Date 11 October 2023

Product change Murrelektronik material number 7000-29521-000000

Current delivery state:

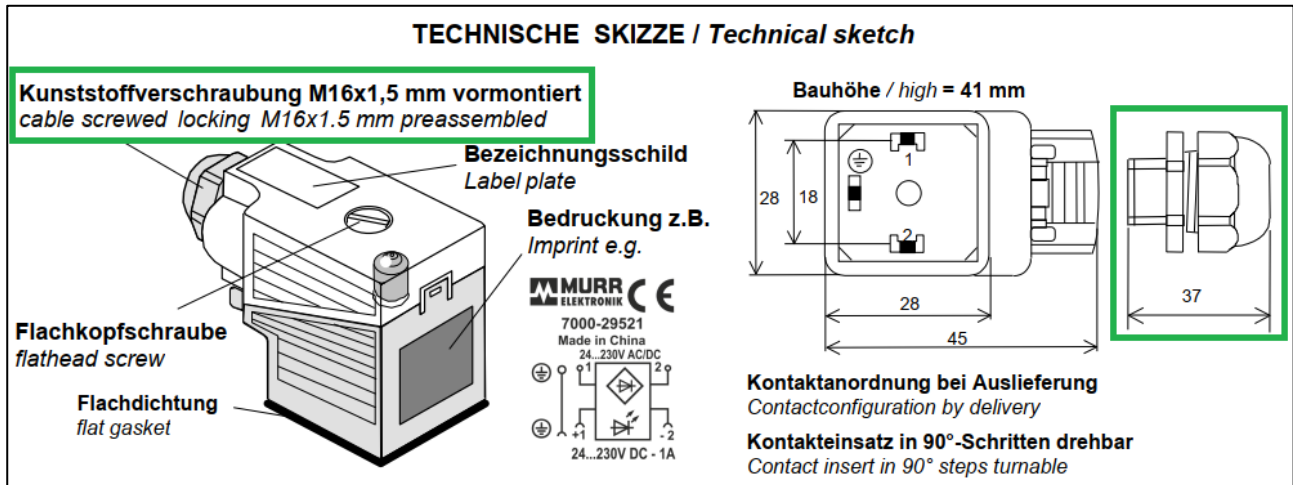
We would like to inform you about a product change of the Field-Wireable Valve Connector (SVS) 7000-29521-000000. On the one hand we had to reduce the rated impulse voltage from 4kV to 2.5kV due to CE requirements and on the other hand the existing M16x1.5mm plastic gland (**pressure screw**) will be replaced by an improved, but in the dimensions longer M16x1.5mm plastic gland (**cable gland**). The cable clamping range remains unchanged from 5mm to 10mm.
